AP1000 DOCUMENT NO. APP-GW-GLR-134	REVISION 1	PAGE 1 of 470	ASSIGNED TO W-Sterdis	OPEN ITEMS (Y/N)
----------------------------------------------	----------------------	-------------------------	---------------------------------	------------------

TITLE: AP1000 DCD Impacts to Support COLA Standardization

AP1000 Standard Combined License Technical Report

AP1000 DCD Impacts to Support COLA Standardization

Figure 2.6.1-1 (Sheet 1 of 4)
Main ac Power System

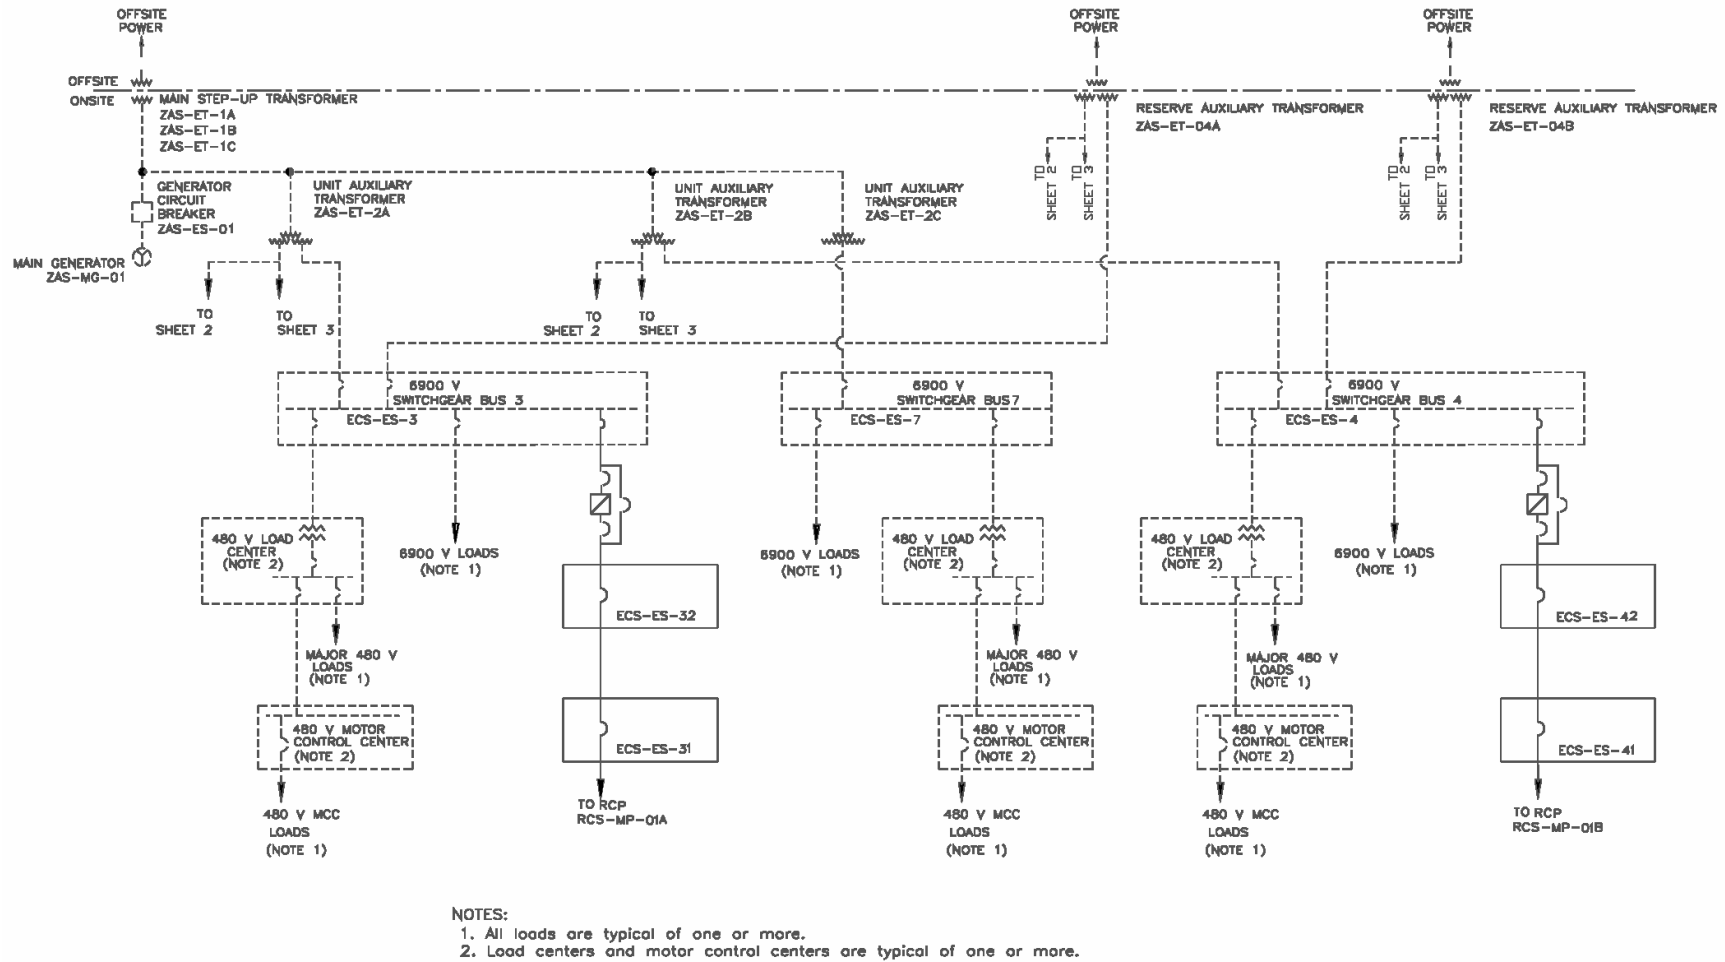
NRC 176

Figure 3H.5-9 (Sheet 1 of 3)

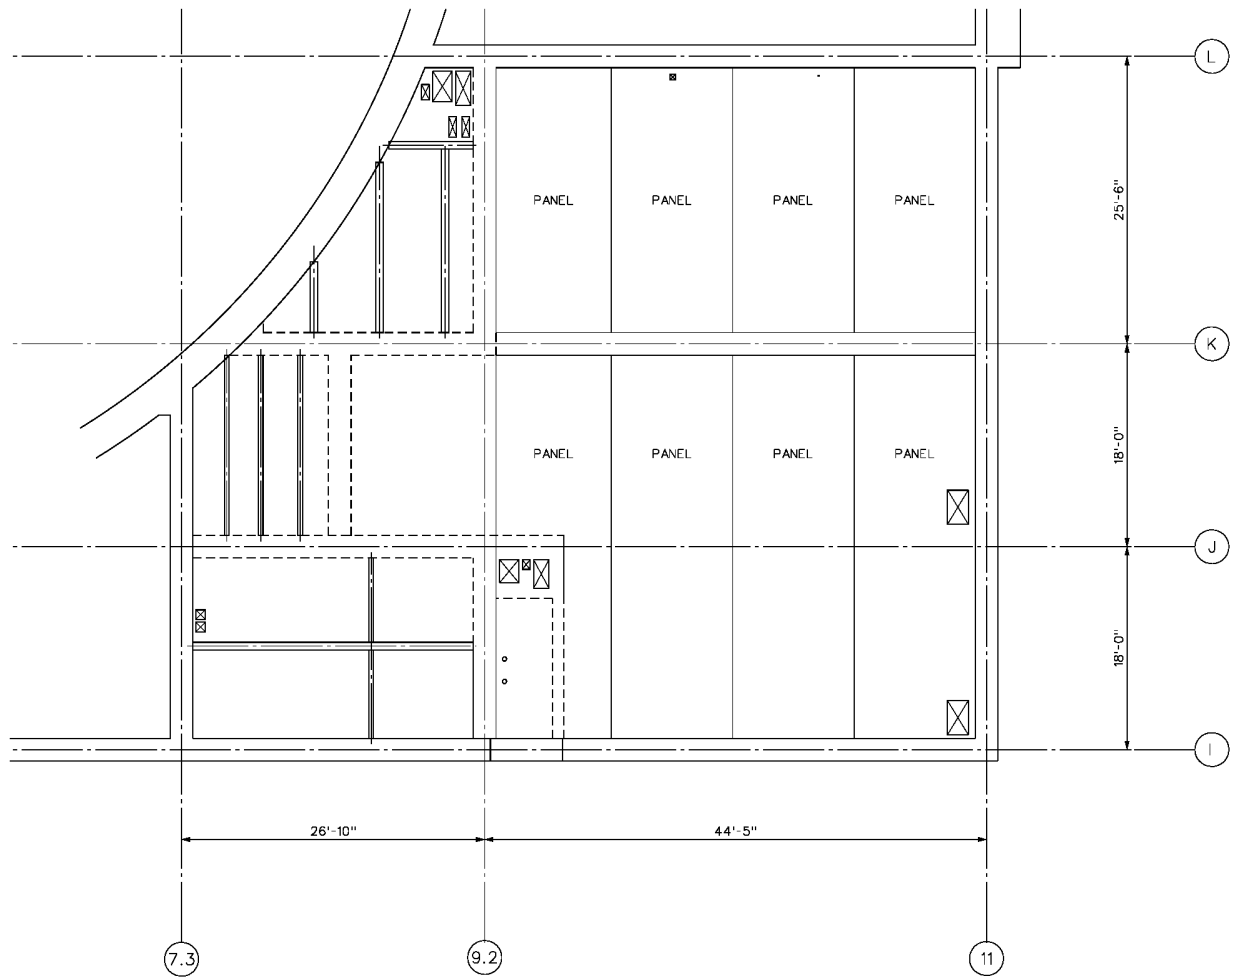
NRC 094 contains corections to Figure 3H.5-9 sheet 1 and Figure 3H.5-12 of the DCD Revision 16 to be consistent with TR 57, APP-GW-GLR-045, Rev 0.

Figure 1.2-1
Reactor Coolant System

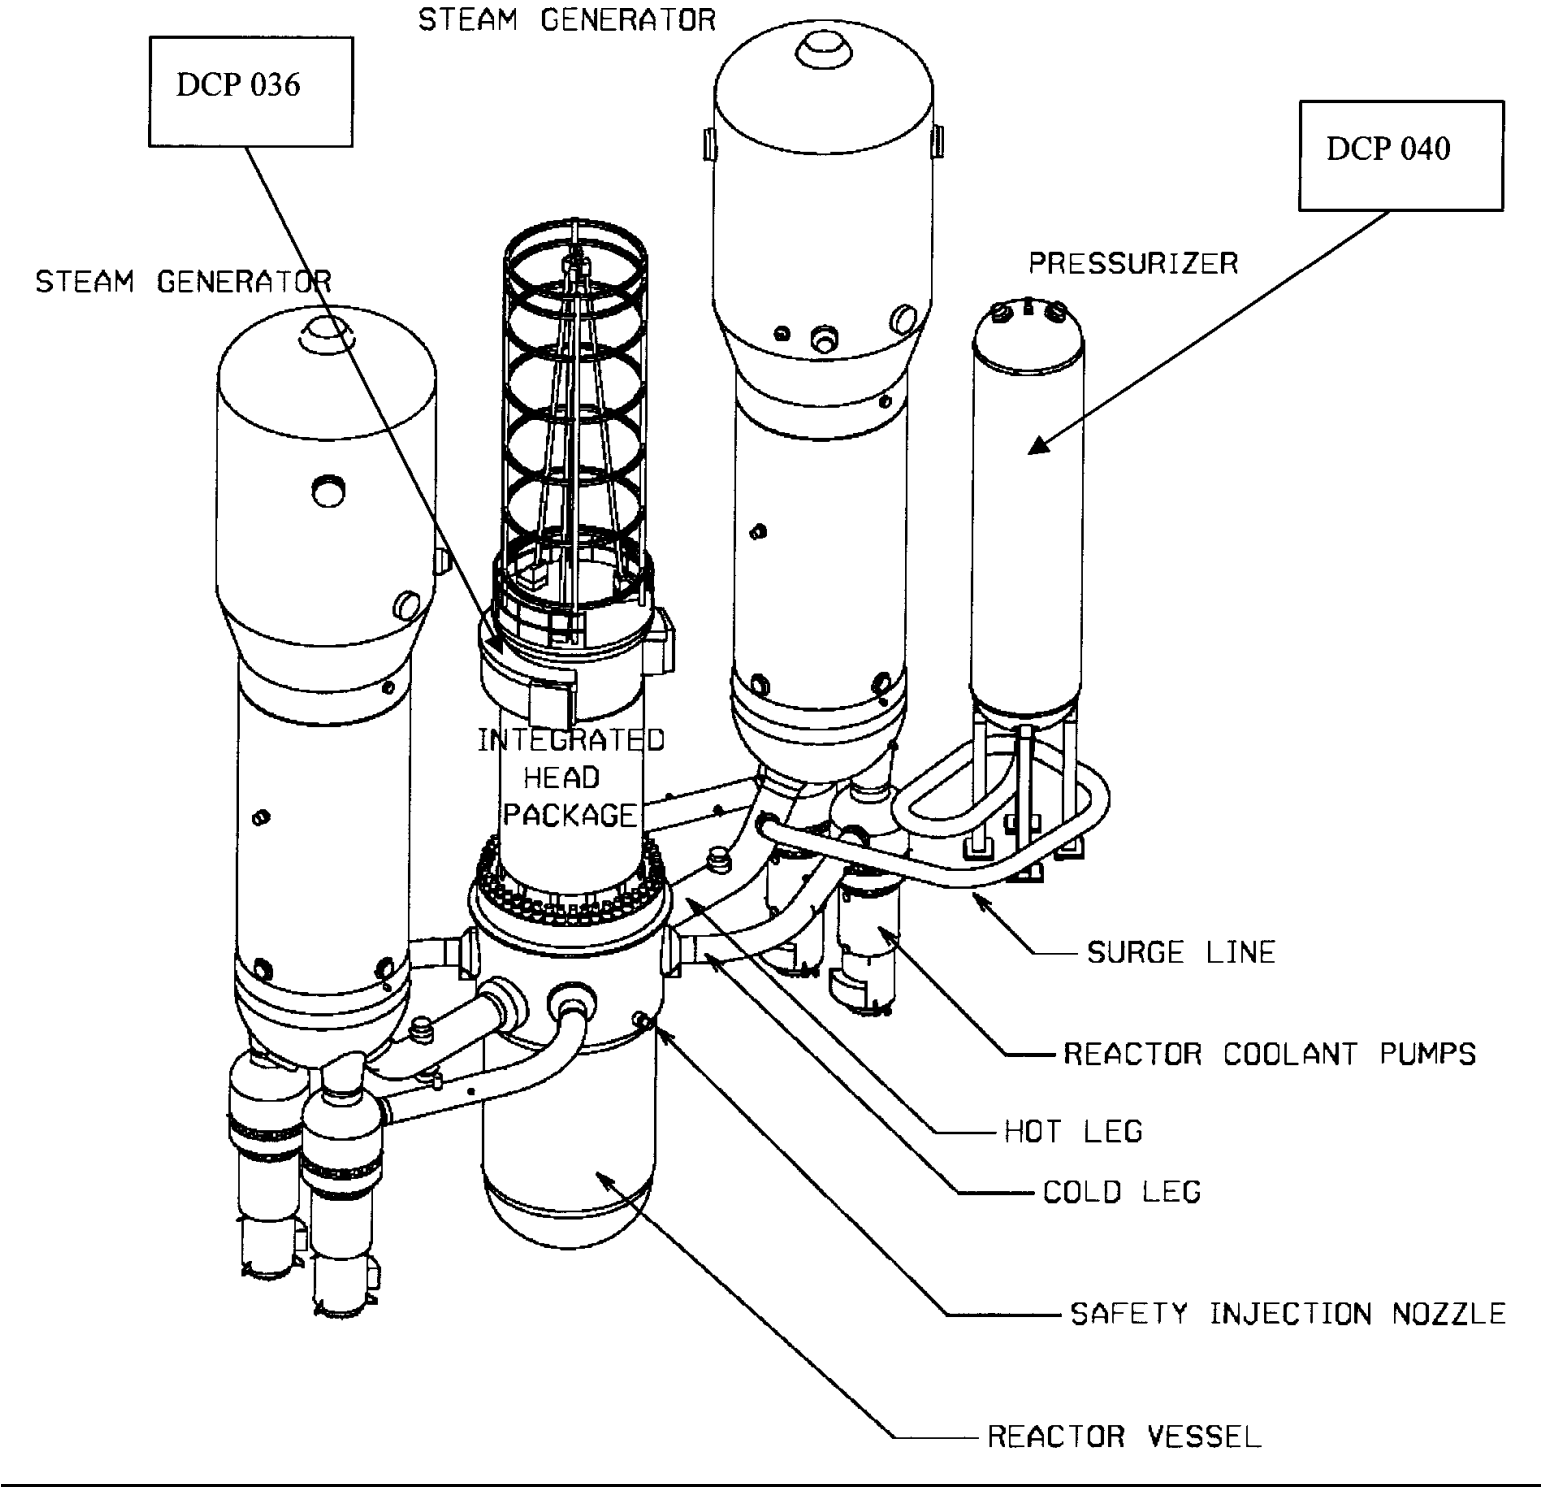
NRC106 contains corrections to Figure 1.2-1, 5.1-2 and Figure 1.2-9. The basis for the change is TR36 APP-GW-GLR-016.
